RELOAD REPORT
Catawba Unit 1 Cycle 7

Duke Power Company
Nuclear Generation Department
Nuclear Engineering Section

8.1 Changes to Technical Specifications

REACTOR CORE SAFETY LIMITS - FOUR LOOPS IN OPERATION, UNIT 1

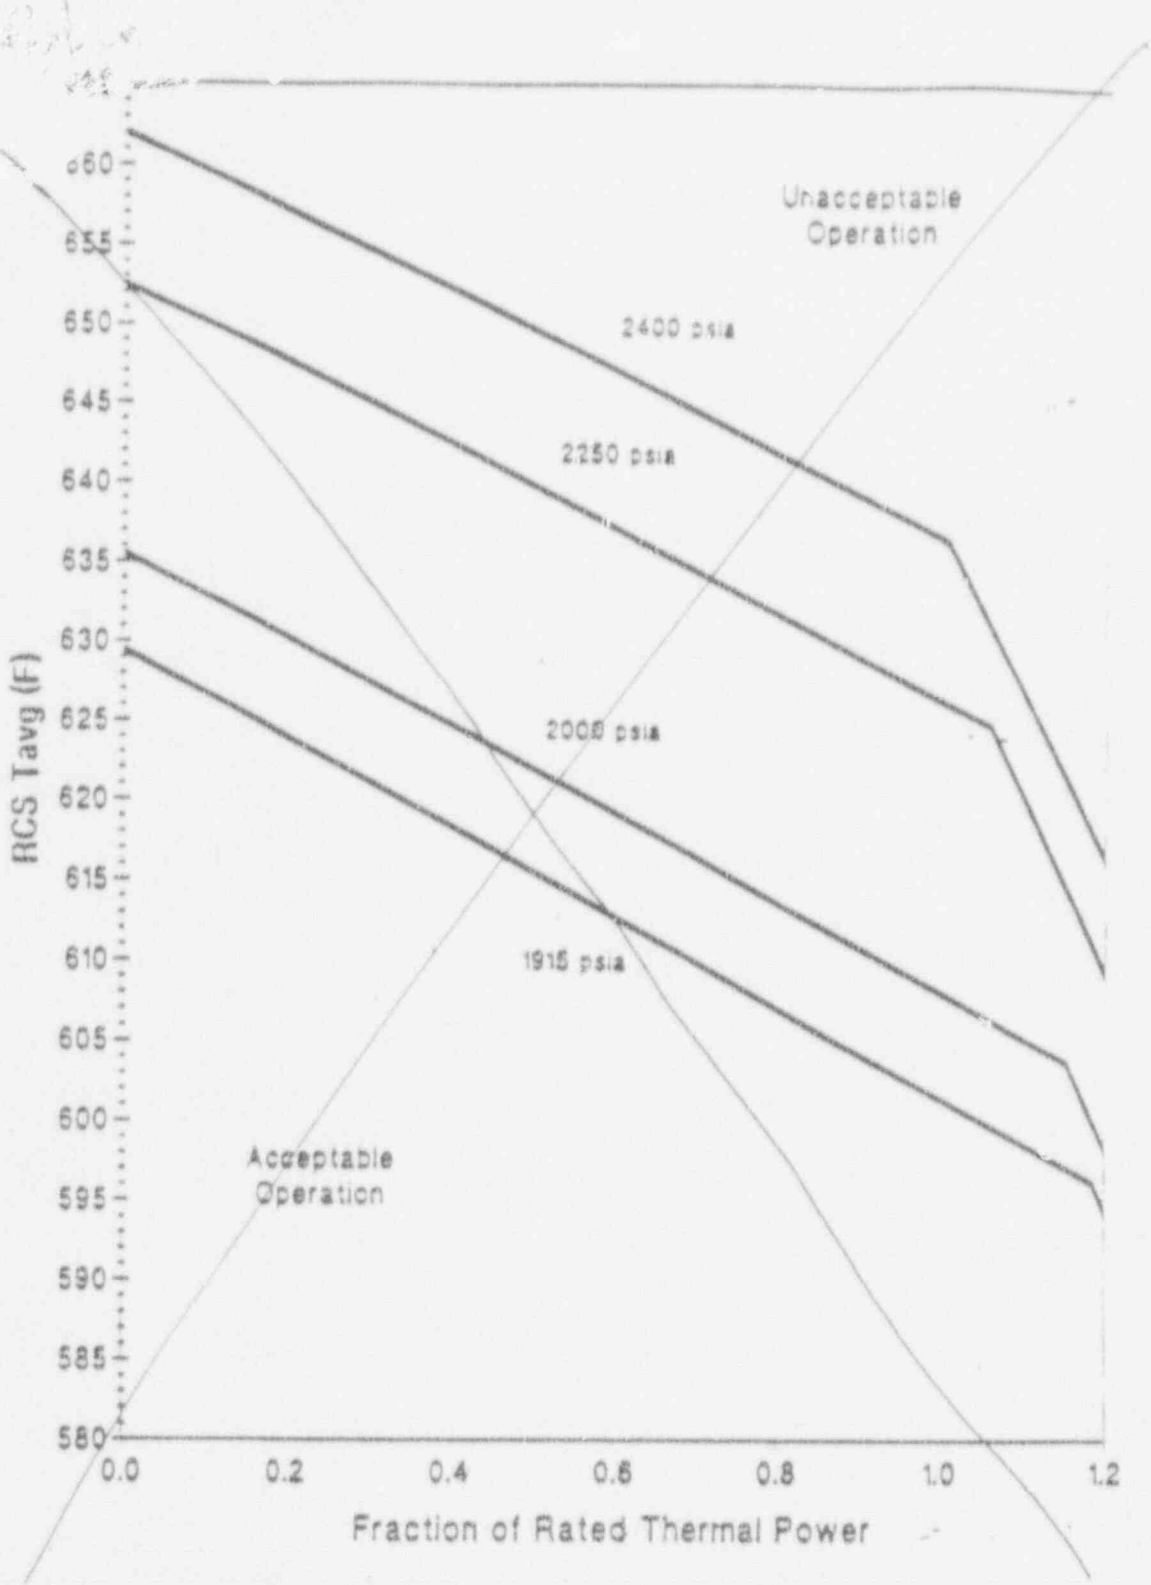
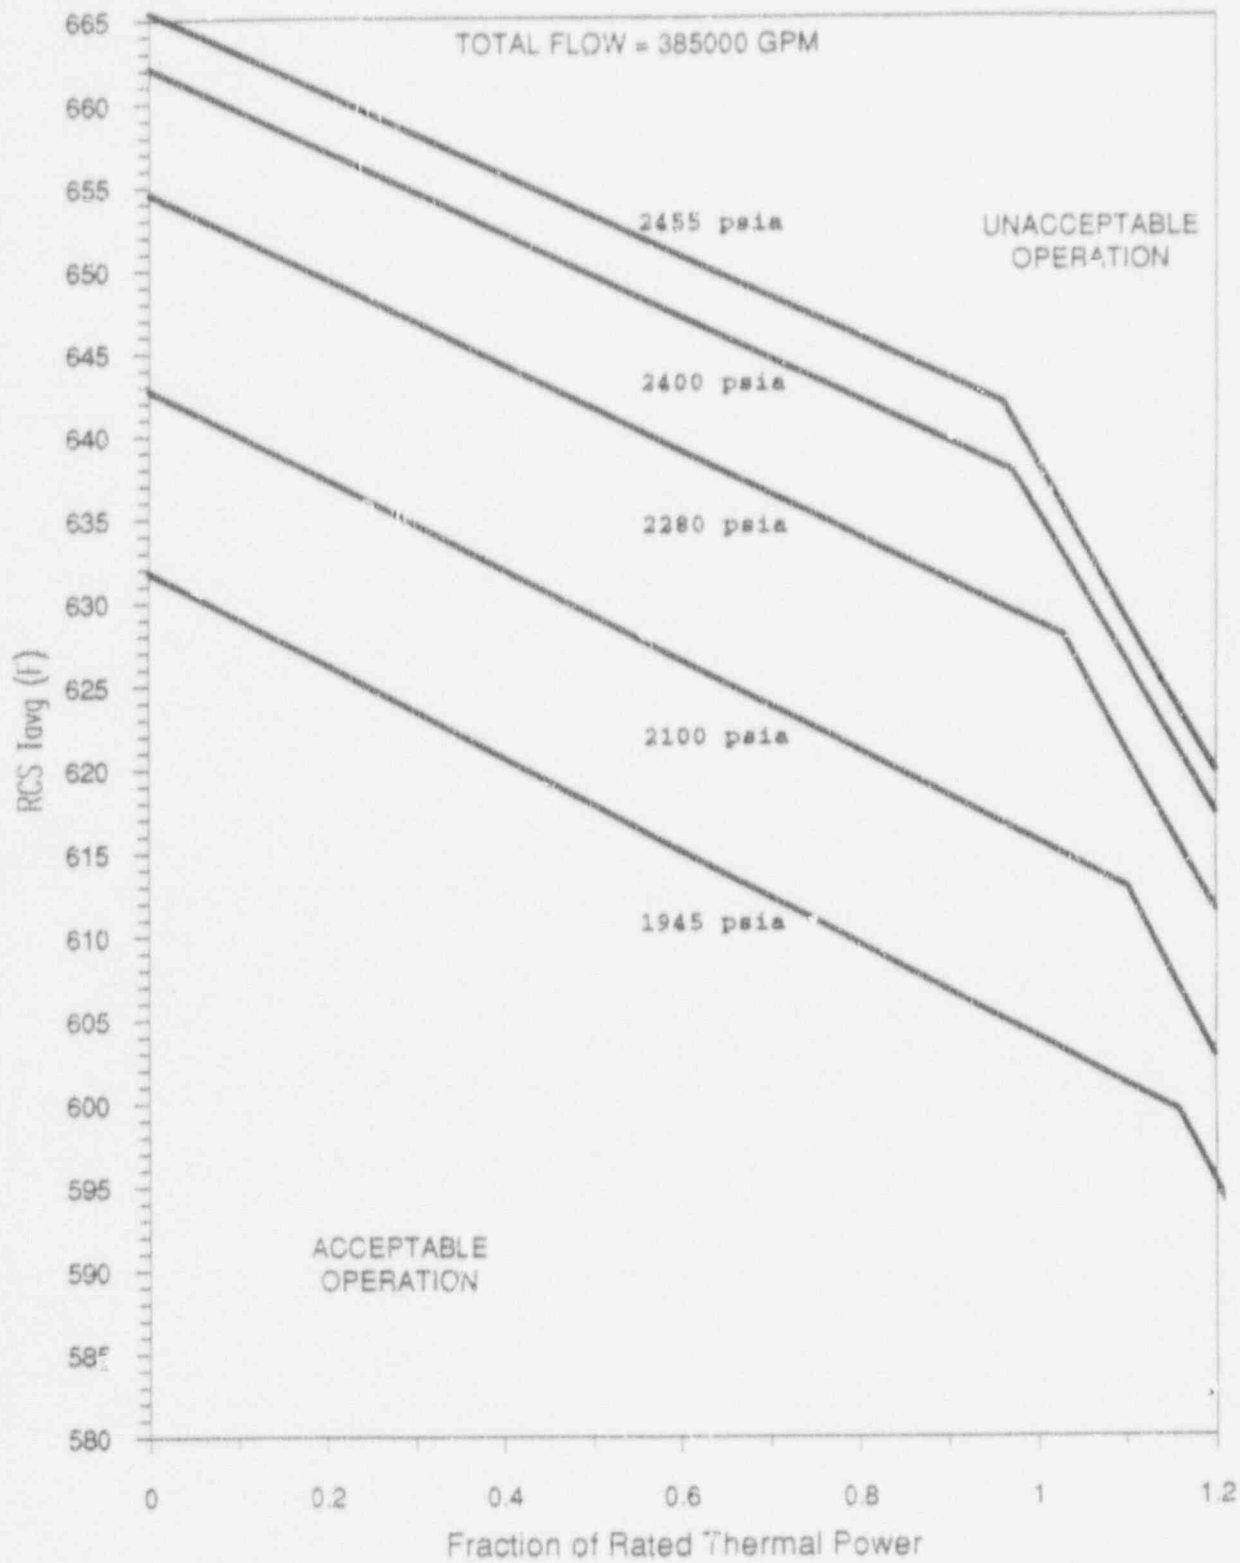
This proposed Technical Specification (TS) revision changes Figure 2.1-1a to reflect use of the BWCMV CHF correlation and Duke Power Company's Statistical Core Design (SCD) methodology with a 1.55 thermal design DNBR limit.

Duke Power Company (DPC) has recalculated the Catawba reactor core safety limits using the BWCMV CHF correlation (Reference 1) along with its Statistical Core Design (SCD) methodology, Reference 5. With the implementation of these design methodologies, the nuclear enthalpy rise hot channel factor, F_{th} , was decreased from 1.55 to 1.50. The proposed changes to Figure 2.1-1 reflect the use of this new design limit as well as the use of BWCMV and the Duke Power Company SCD.
